Block 16 Section 10

1.0 Context and Character

Community and public domain Increased Public Domain

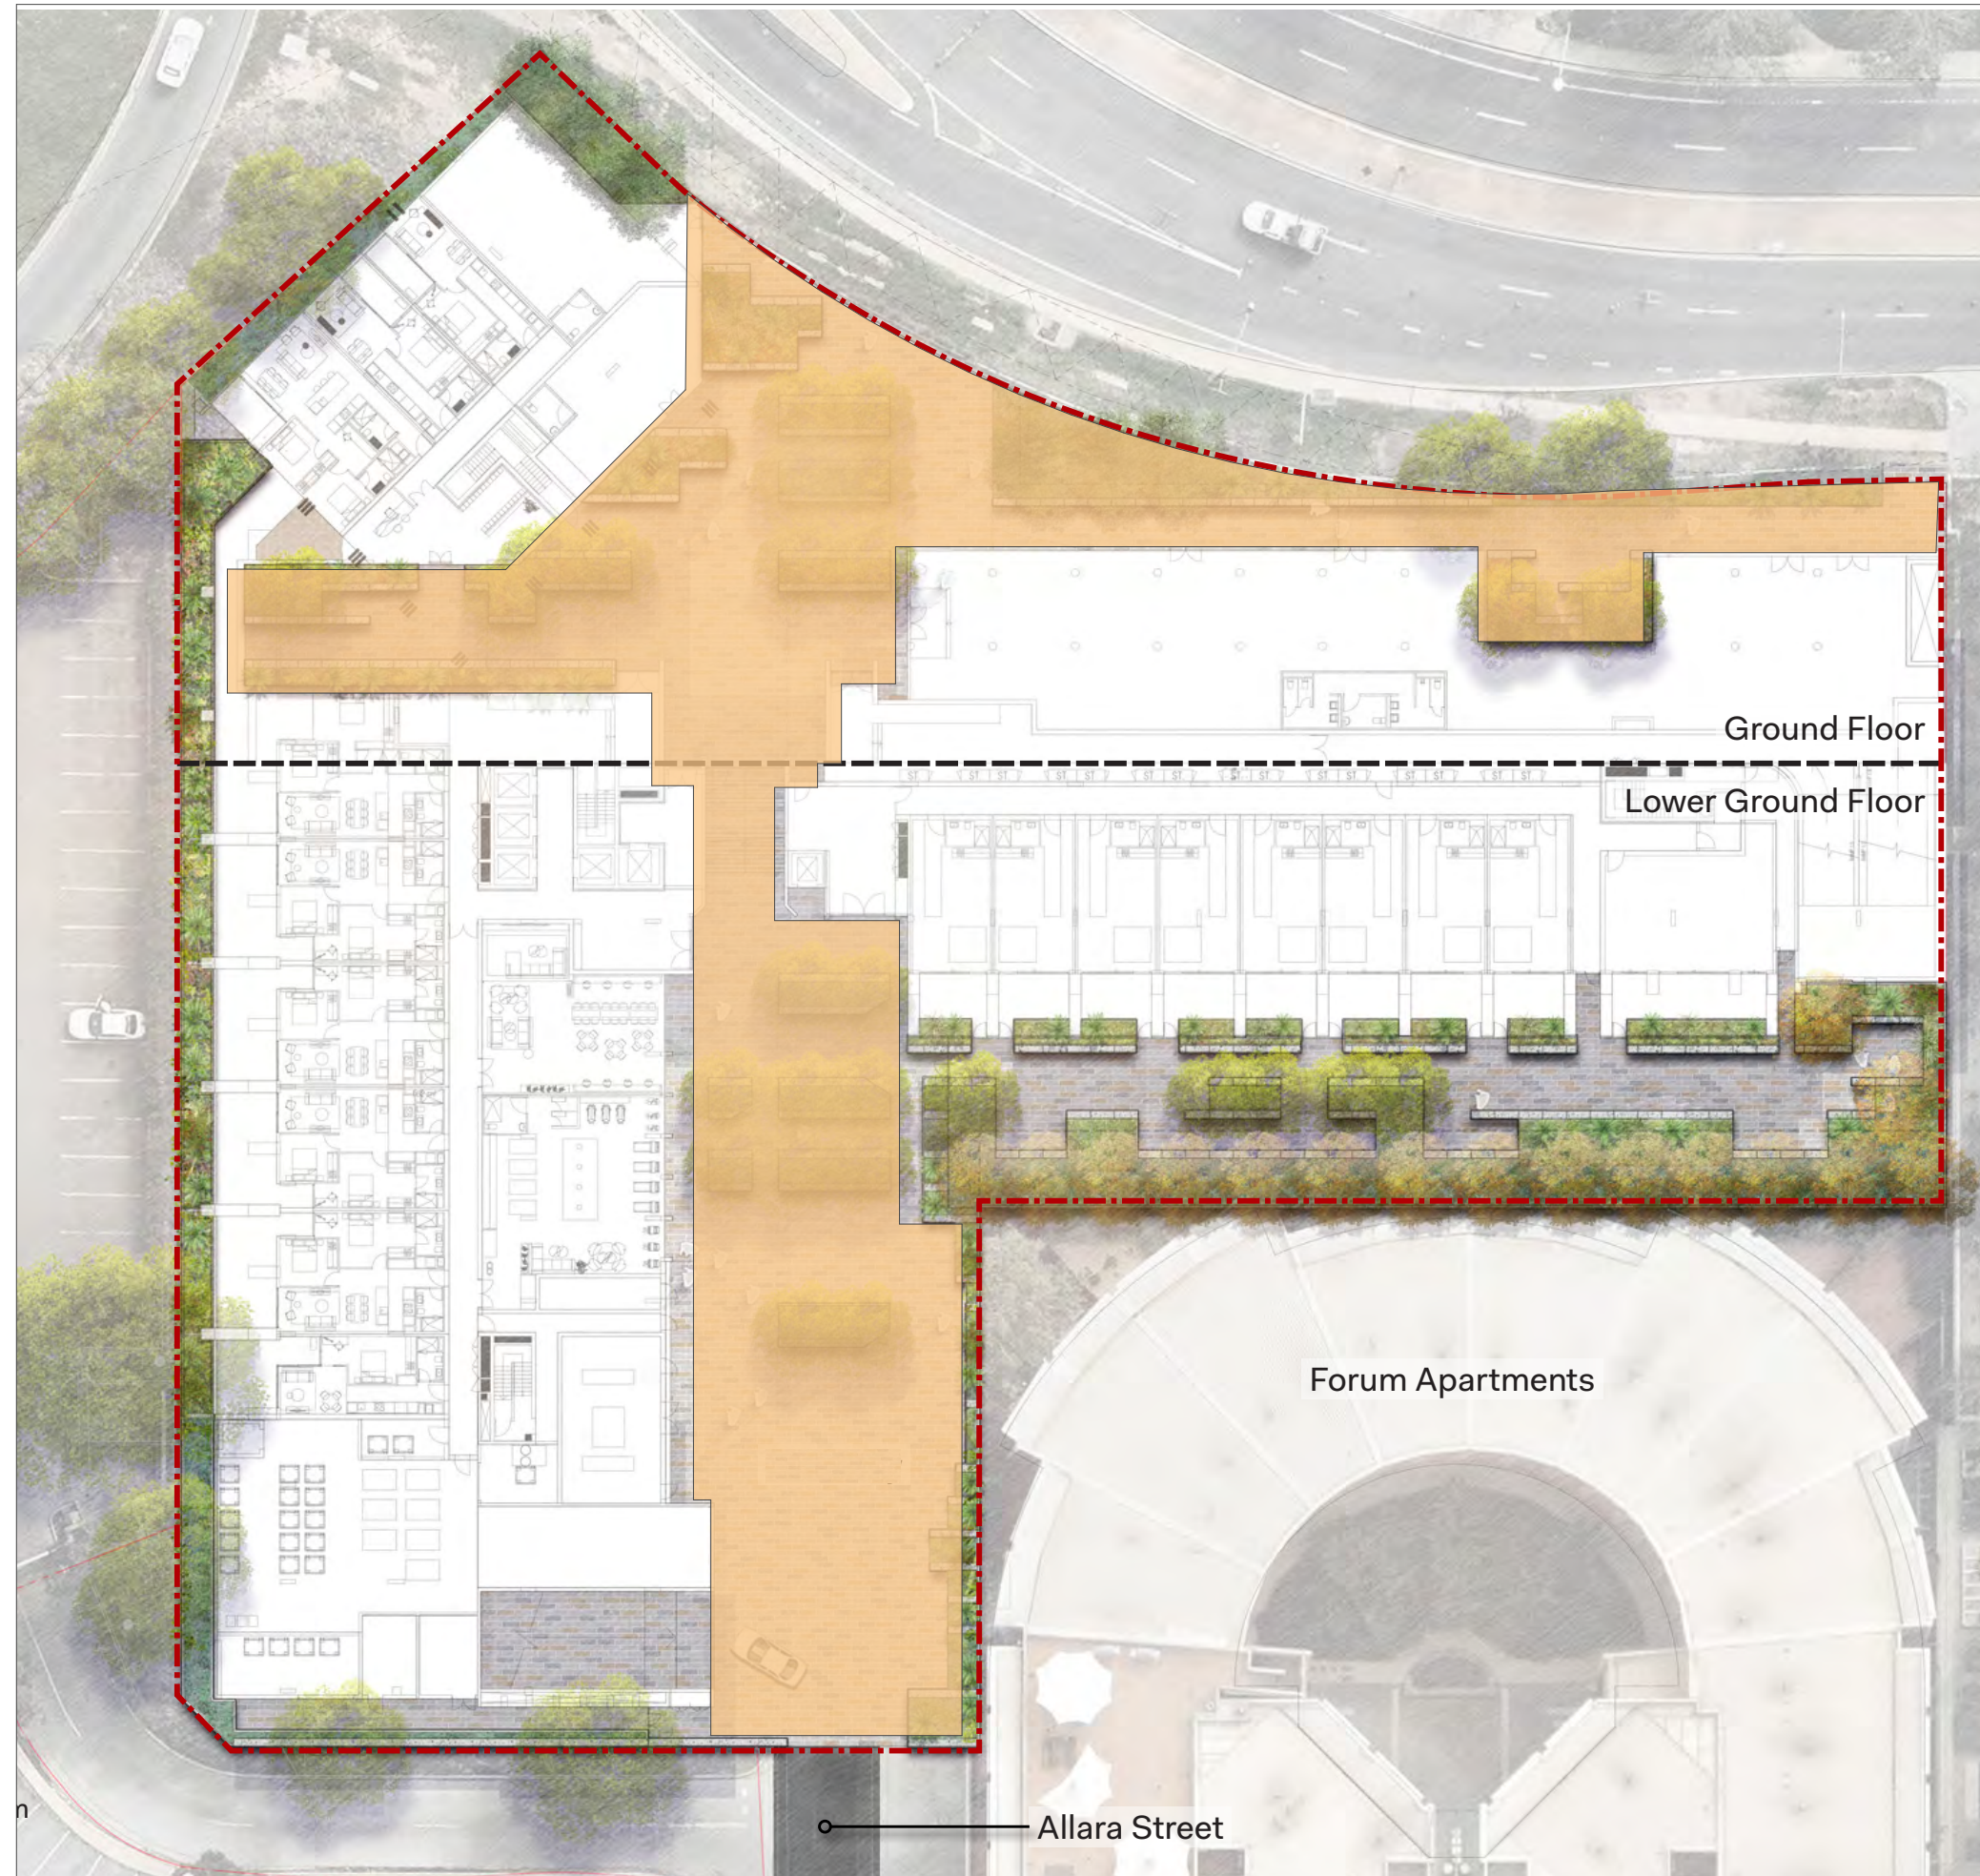
9.1 The Panel continues to support the through-site connection from London Circuit to Allara Street (see 4.1). The Panel, however, considers this link should be open to the sky and that opportunities exist to increase activation and visual permeability of this link as well as provide site permeability at other locations on the site. As such the Panel encourages the proponent team to consider how open access foyers and pedestrian pathways to a variety of destinations may be accommodated in the proposed development to assist activation and community interaction.

Community and public domain Sun drenched plaza

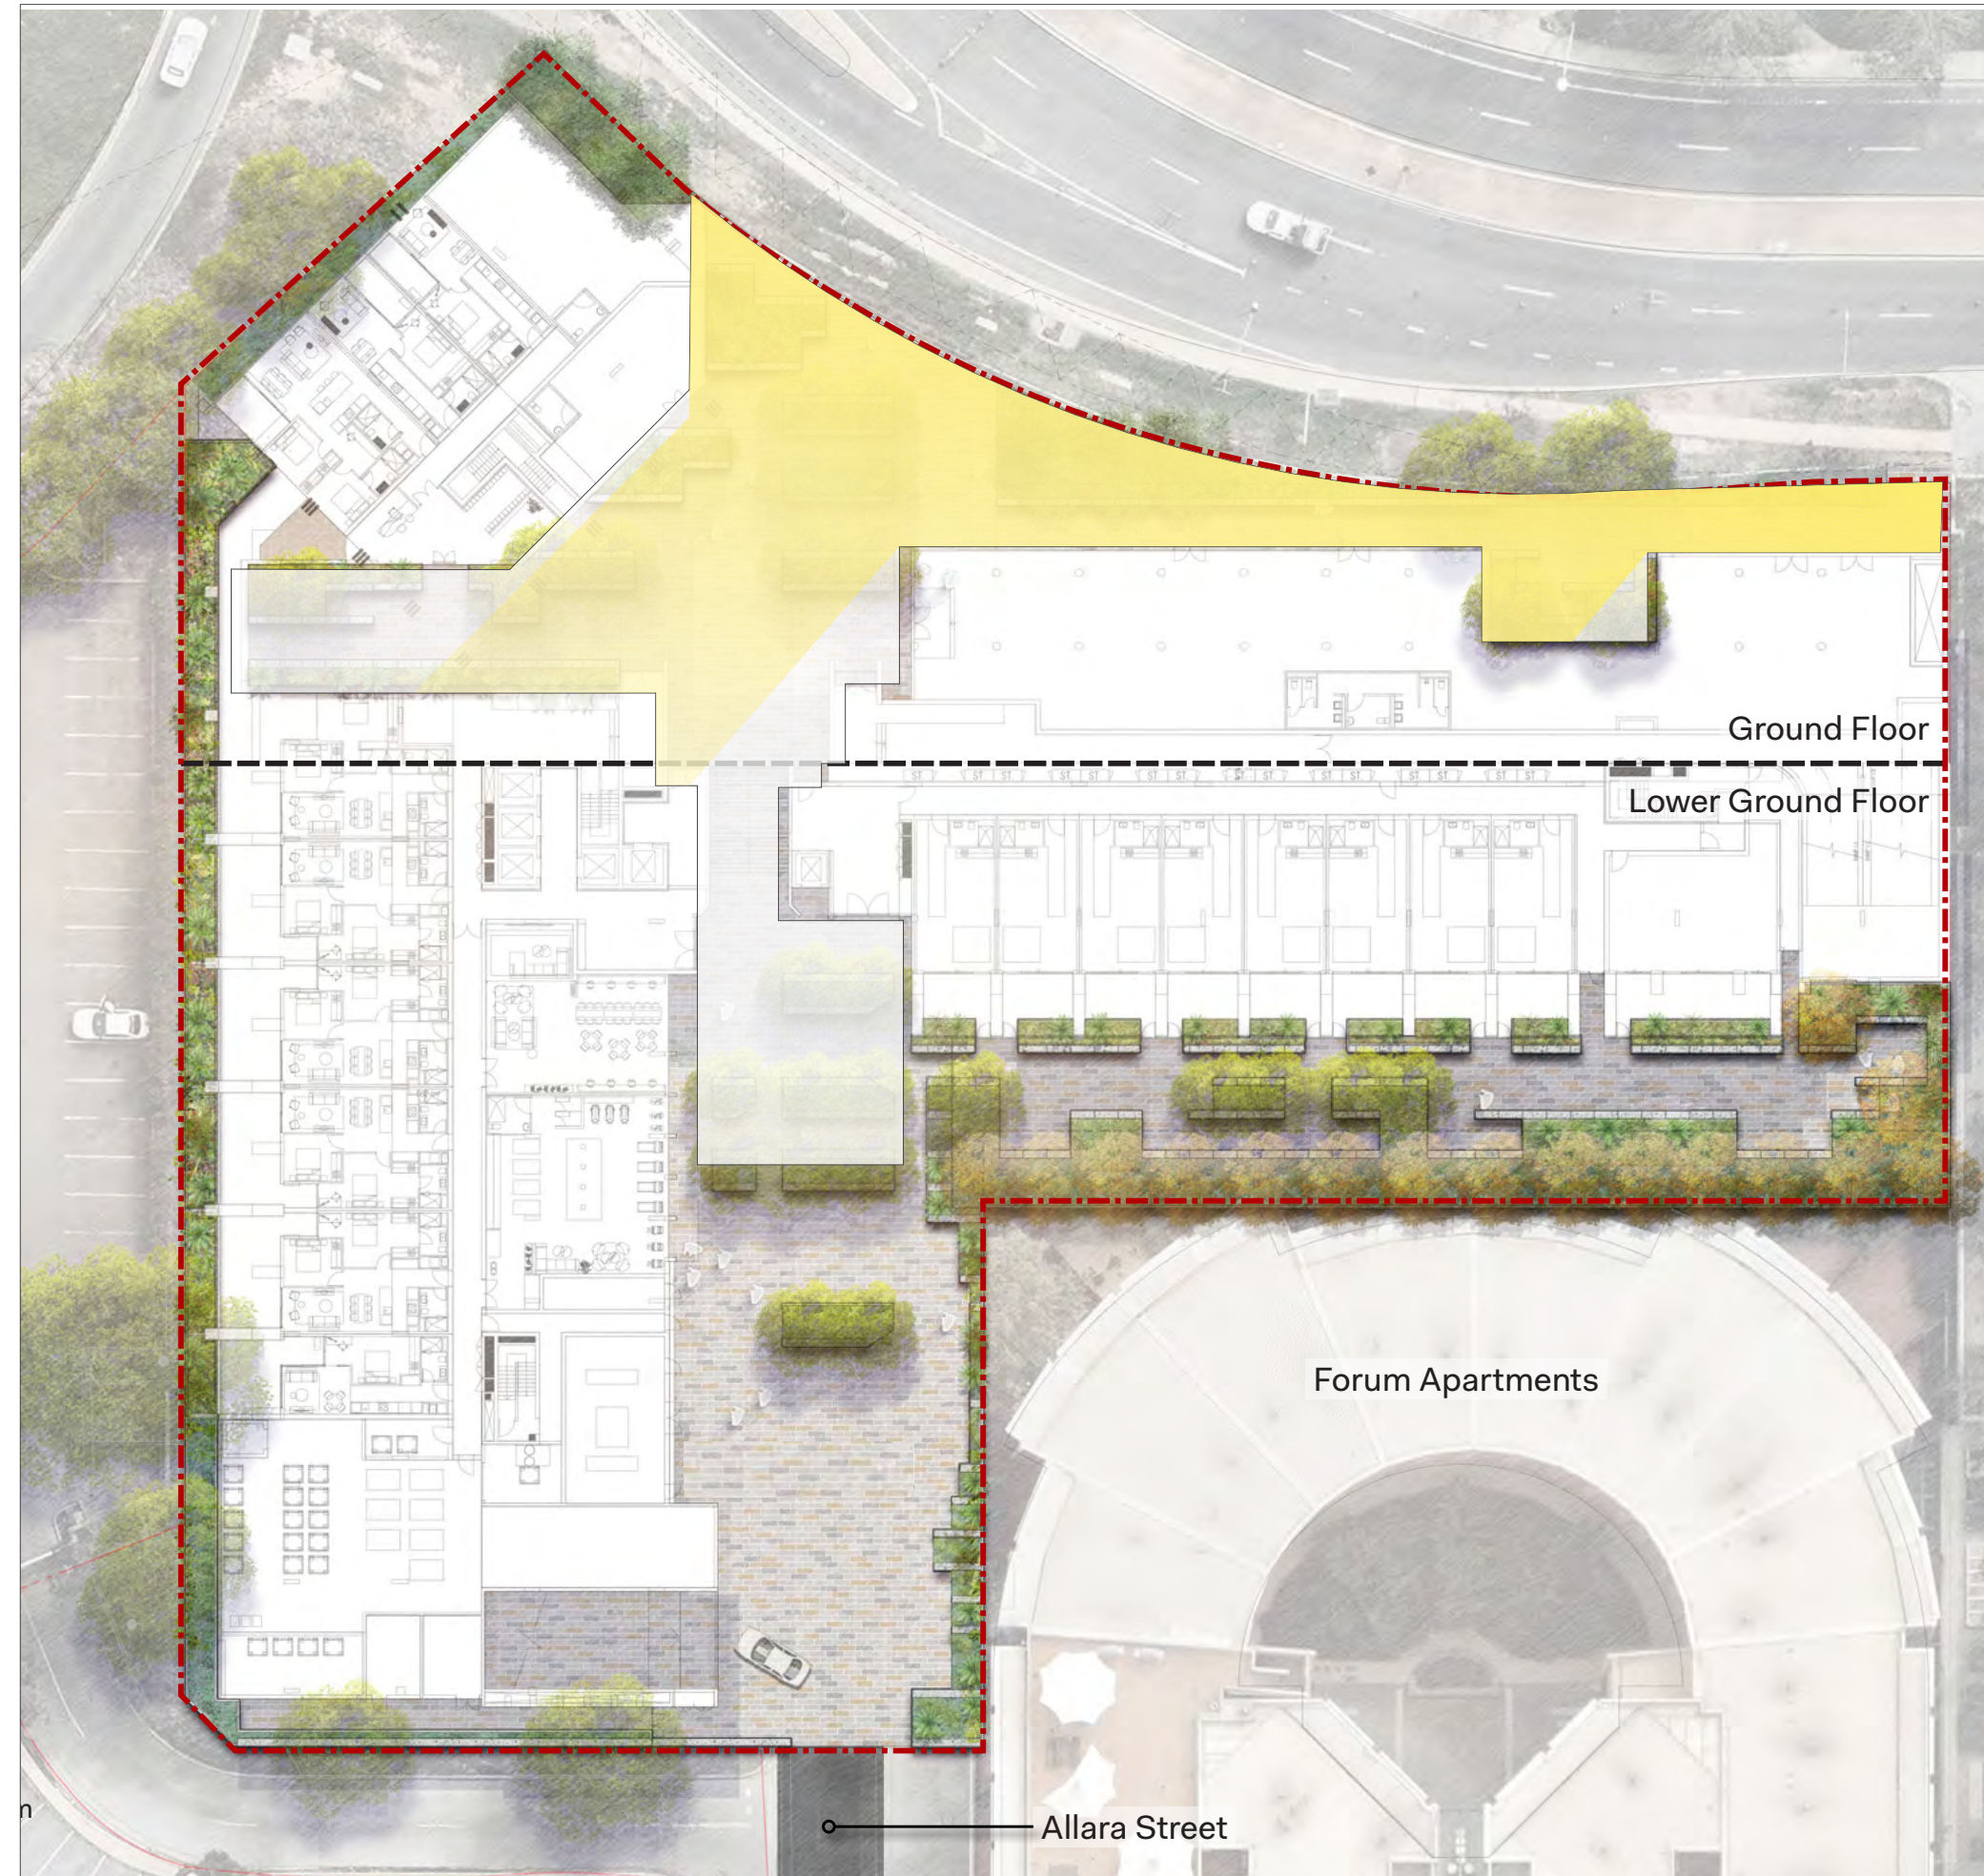
9.1 The Panel continues to support the through-site connection from London Circuit to Allara Street (see 4.1). The Panel, however, considers this link should be open to the sky and that opportunities exist to increase activation and visual permeability of this link as well as provide site permeability at other locations on the site. As such the Panel encourages the proponent team to consider how open access foyers and pedestrian pathways to a variety of destinations may be accommodated in the proposed development to assist activation and community interaction.

Community and public domain Open to sky

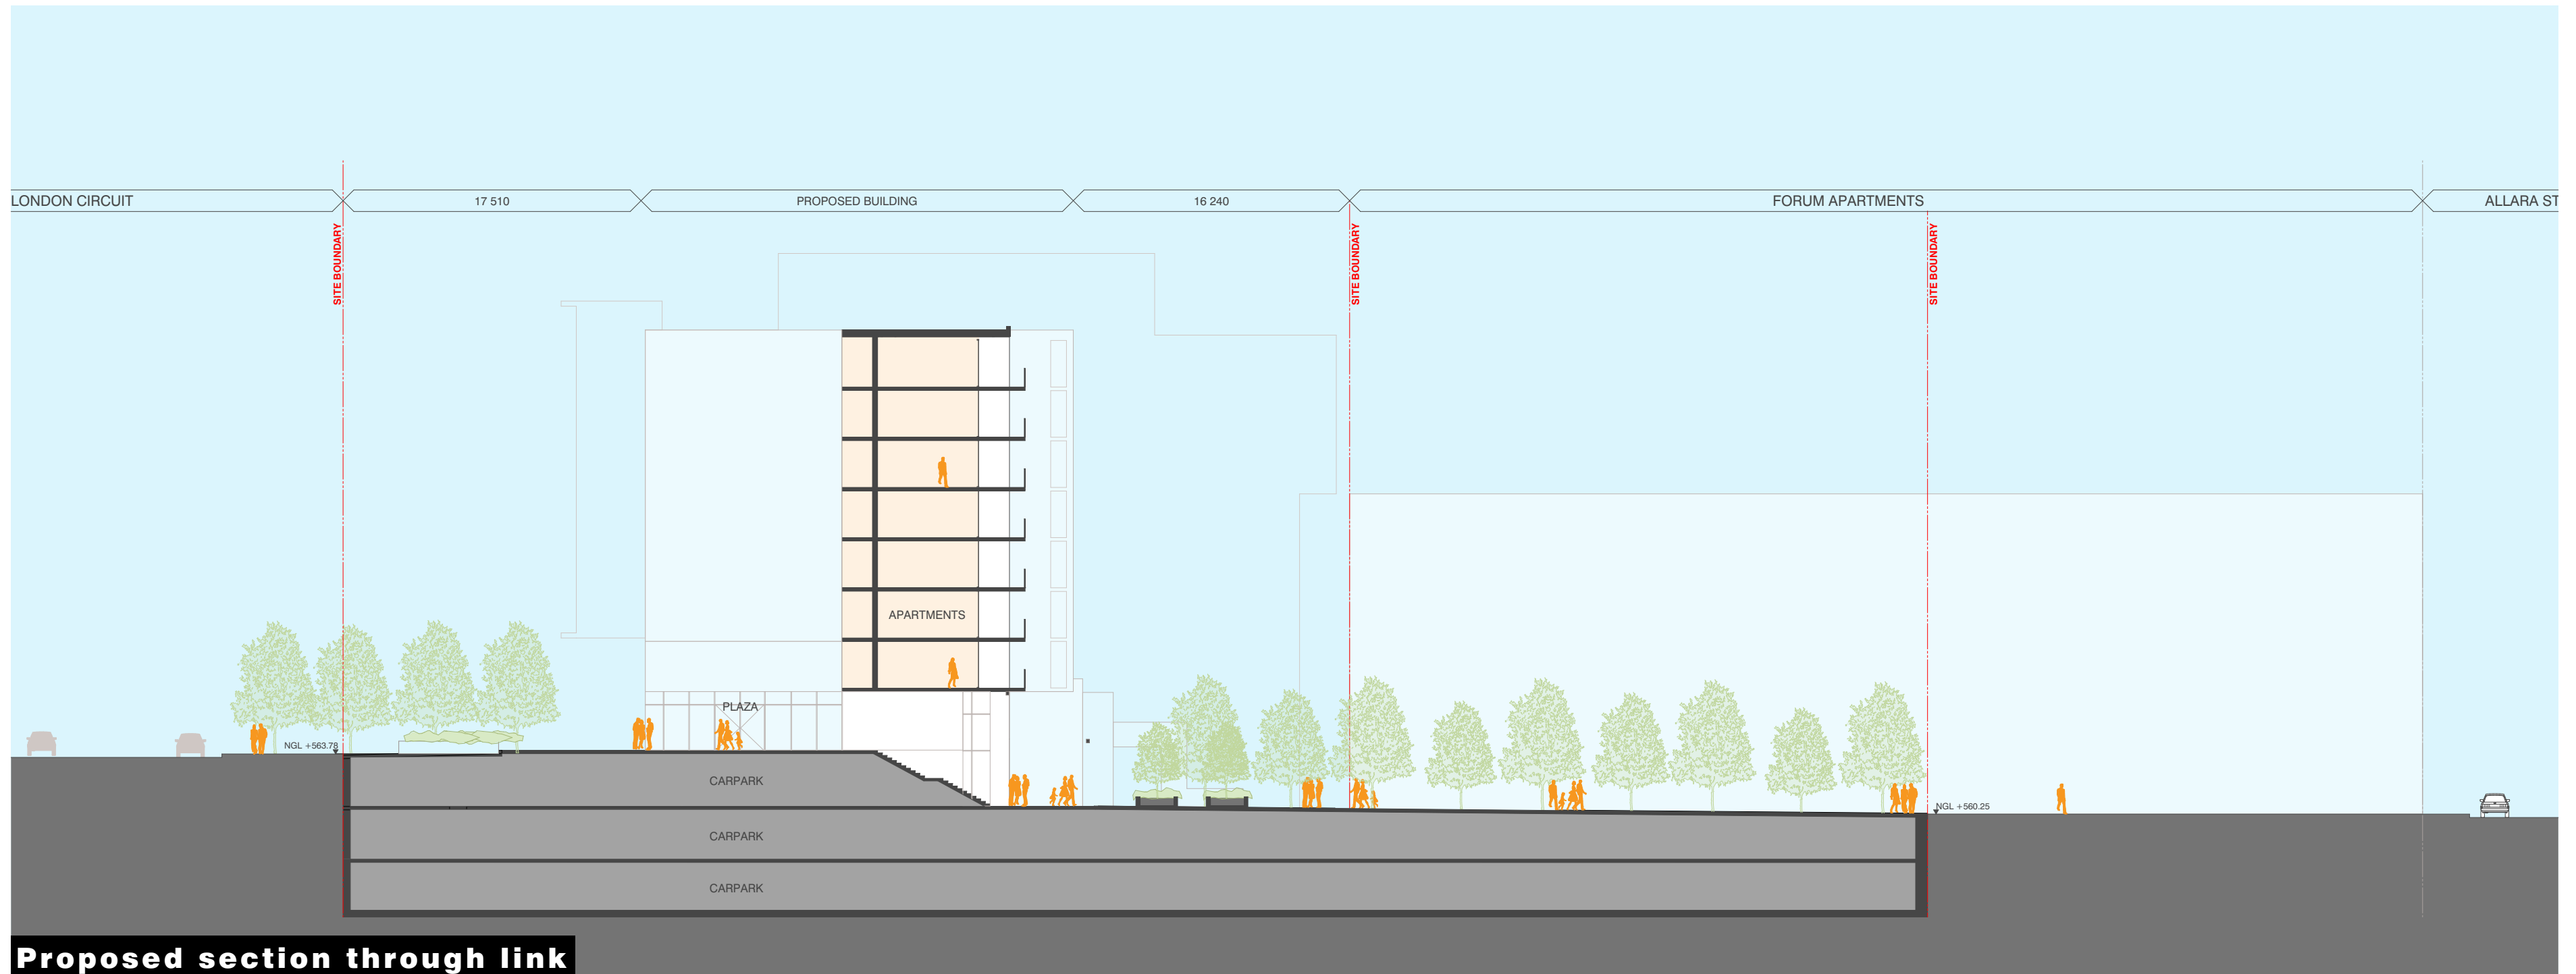
9.1 The Panel continues to support the through-site connection from London Circuit to Allara Street (see 4.1). The Panel, however, considers this link should be open to the sky and that opportunities exist to increase activation and visual permeability of this link as well as provide site permeability at other locations on the site. As such the Panel encourages the proponent team to consider how open access foyers and pedestrian pathways to a variety of destinations may be accommodated in the proposed development to assist activation and community interaction.
